**Summary and Analysis of Comments:
Control of Emissions of Air Pollution
from Locomotive Engines and Marine
Compression Ignition Engines Less than
30 Liters Per Cylinder**

Assessment and Standards Division
Office of Transportation and Air Quality
U.S. Environmental Protection Agency

**Variable-Pitch or Electronically-Coupled Engines
(shown for engine capable of operating on E3 cycle)
NTE Zone: Sub zones and FEL Multipliers**

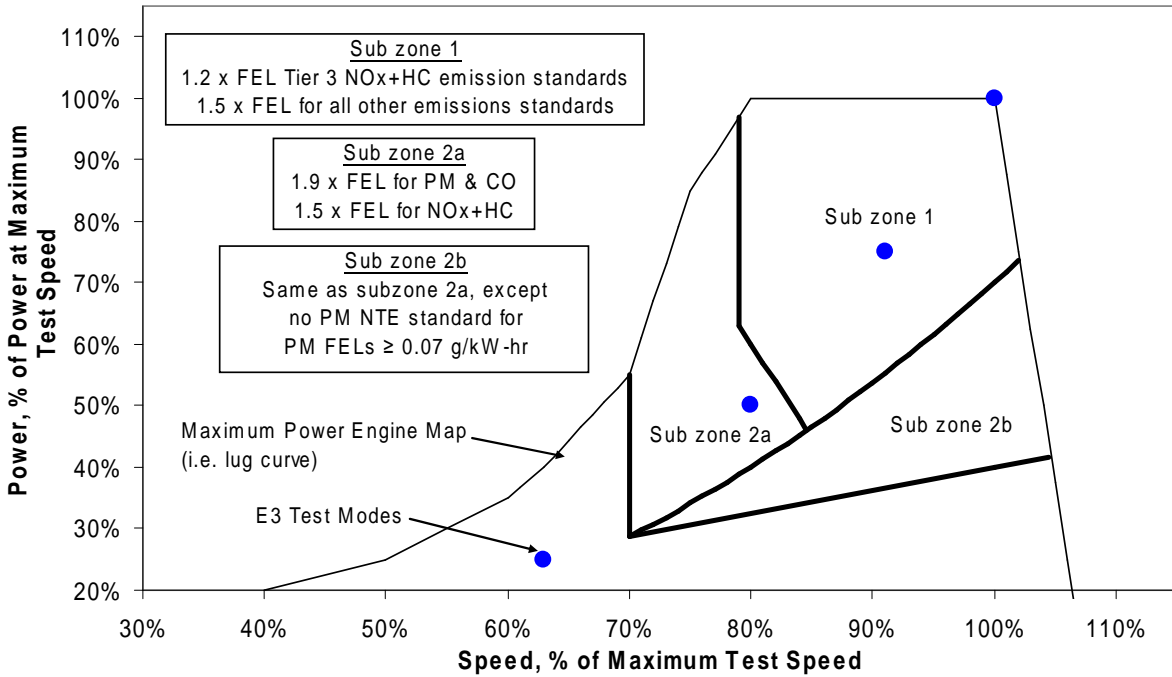
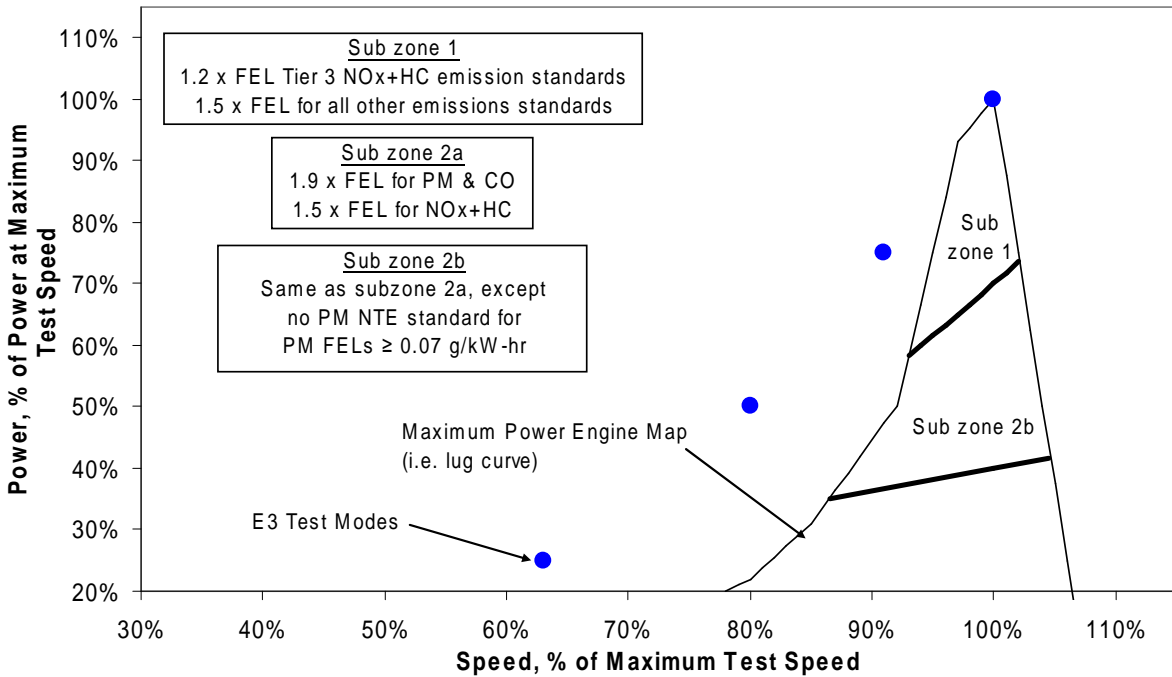
Caterpillar Inc. (Caterpillar) OAR-2003-0190-0485, 0498, 0580.1, 0591.1, 0822
Engine Manufacturers Association (EMA) OAR-2003-0190-0575.1

After the comment period, we continued to work with the marine engine manufacturers to better understand the unique characteristics of these engines. As discussed above, applications using variable-pitch or electronically-coupled engines vary greatly. In some applications, the engine may operate similar to a fixed pitch propeller engine and others more

similar to a constant speed engine. In addition, some engines may operate over a wide range of speed and loads more similar to a nonroad engine.

Although a single NTE zone is used for all variable-pitch or electronically-coupled engines, this zone varies in appearance by power curve. For an engine capable of operating over the E3 duty cycle, it approaches the NTE zone for nonroad engines. In this case, the NTE limits are based on a comparison to the E3 duty cycle results. For engines that are not capable of operating over the E3 duty cycle, and are better reflected by the E2 duty cycle, the NTE zone and limits approach those for constant speed engines. In this case, the NTE limits are based on a comparison to the E2 duty cycle results. The following two figures present the NTE zone and limits and give an indication of how the shape of the zone is affected by the power curve of the engine.
